<b>FDI</b>	<b>ENGINEERING CHANGE ORDER</b>		<b>ECO NO: 09-012</b>
			<b>Page 1 of 3</b>
<b>TITLE</b>	<b>DWG NO.</b>	<b>CURRENT REV</b>	<b>NEW REV</b>
LCD Carrier 3-5		1.0	1.1

<b>FDI</b>	<b>ENGINEERING CHANGE ORDER</b>		<b>ECO NO: 09-013</b>
			<b>Page 1 of 4</b>
<b>TITLE</b>	<b>DWG NO.</b>	<b>CURRENT REV</b>	<b>NEW REV</b>
LCD Carrier 3-5		1.1	1.2

Figure 1 C10 Polarity

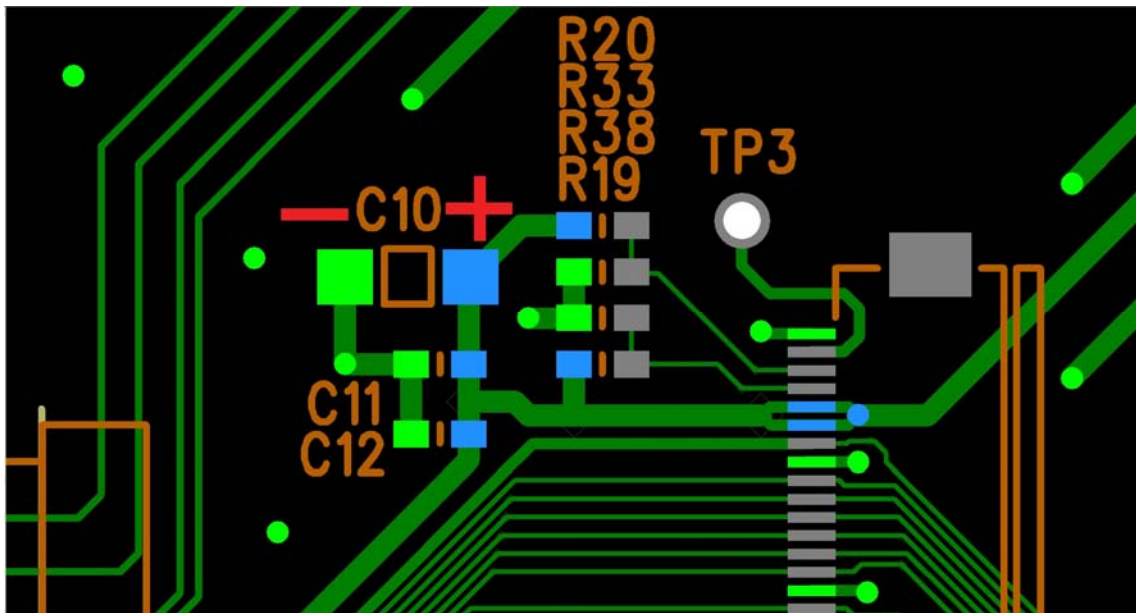
As the LCD Carrier 3-5 REV 1 was sent to production, it was discovered that the Bill Of Materials calls for Tantalum capacitors at C10, C31, C34. However, there are no polarity markings on the REV 1 PCB.

Reason for change: 1. BOM calls for Tantalum Capacitors, but there are no polarity markings on the PCB		<b>Disposition/Affectivity</b>	
		Use as is	x
		Rework to ECO	
		Scrap & Rebuild	
		Record Change Only	
Prepared by:	JG	Date:	07/15/2009
Approved by:		Date:	
Approved by:		Date:	
Approved by:		Date:

1. The BOM will be corrected to include ceramic caps for future builds of REV 1 and for future hardware revisions.
2. To avoid production delays we will use the Tantalum caps on the first production lot of LCDC 3-5 REV1. Diagrams to indicate cap polarity are provided in Figures 1 thru 3.

Figure 1 General Area of Cut (LCDC 3-5 REV1 TOP Side)

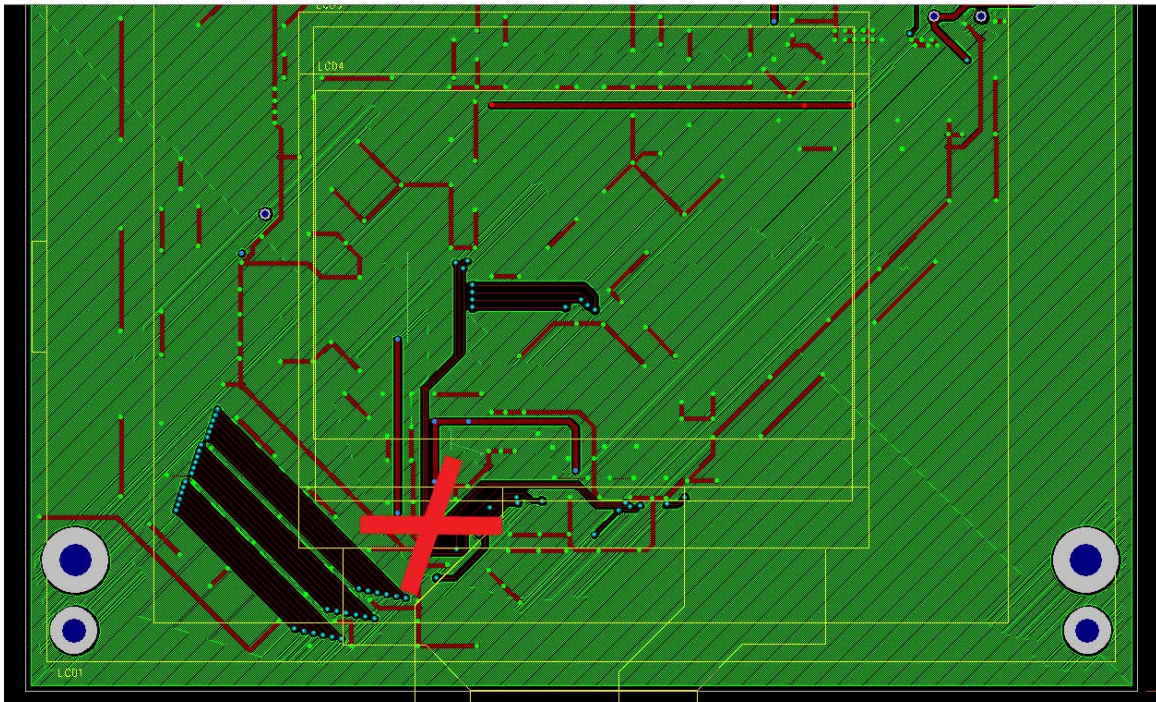
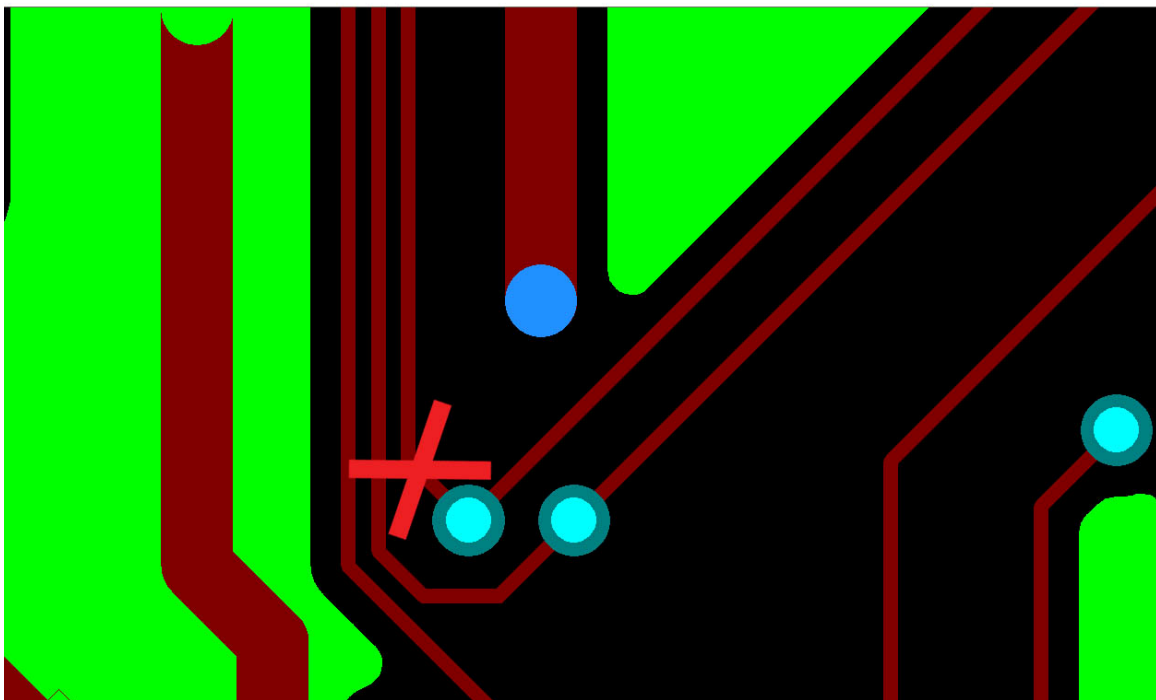
Software driver development for the 3.5" Okaya also uncovered a schematic error on the SPI bus. Although, SPI is properly terminated at the LCD and at the main 50-pin connector back to ARM Carrier, an error existed in the connection between the two schematic pages that effectively connected MISO to SDI (Serial Data In) of the LCD. This obviously should have been connected to MOSI.

1. Cut EXT\_MISO trace between J4.45 and J10.50. The cut is made on the TOP side of the PCB. Figure 1 shows the general area of the cut and Figure 2 shows a detail of the cut.

Figure 5 Rework Wire Connection at J4.33

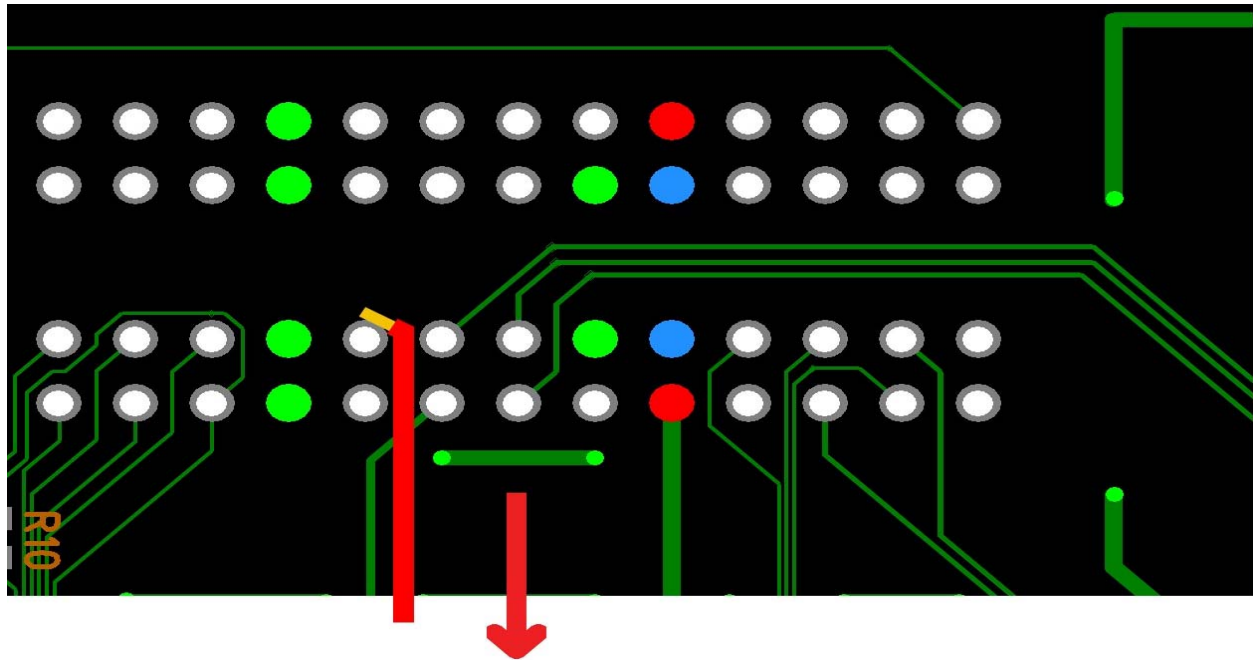
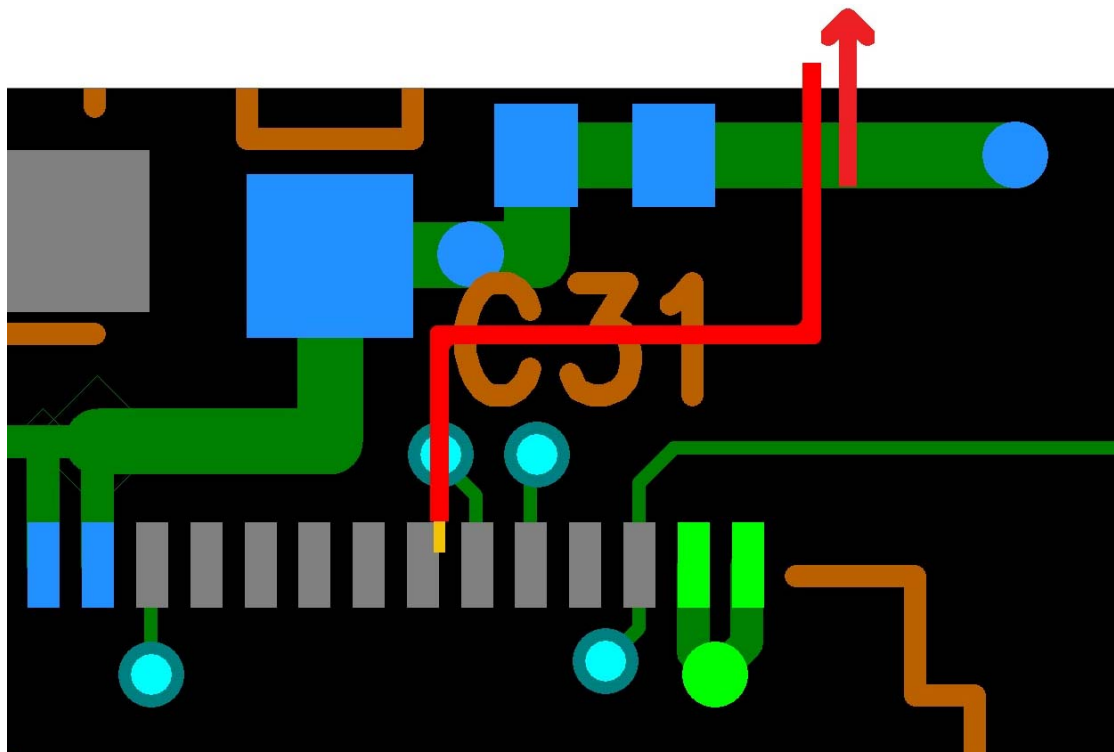
When the initial hardware design was done, it was assumed that an internal pull down would be sufficient termination for the SHUT pin of the Okaya 3.5" LCD, and the pin was left not connected. However, during software driver development, it was discovered that the LCD must see a falling edge on this signal during startup. The LCDPWR signal was selected for this task since its purpose of controlling backlight power was obsoleted on the LCDC 3-5 which uses PWM for backlight control.

3. Add a 30 AWG Solid rework wire between J4.33 and J10.48. Figure 5 shows a detail of the connection at J4 and Figure 6 illustrates the connection at J10.
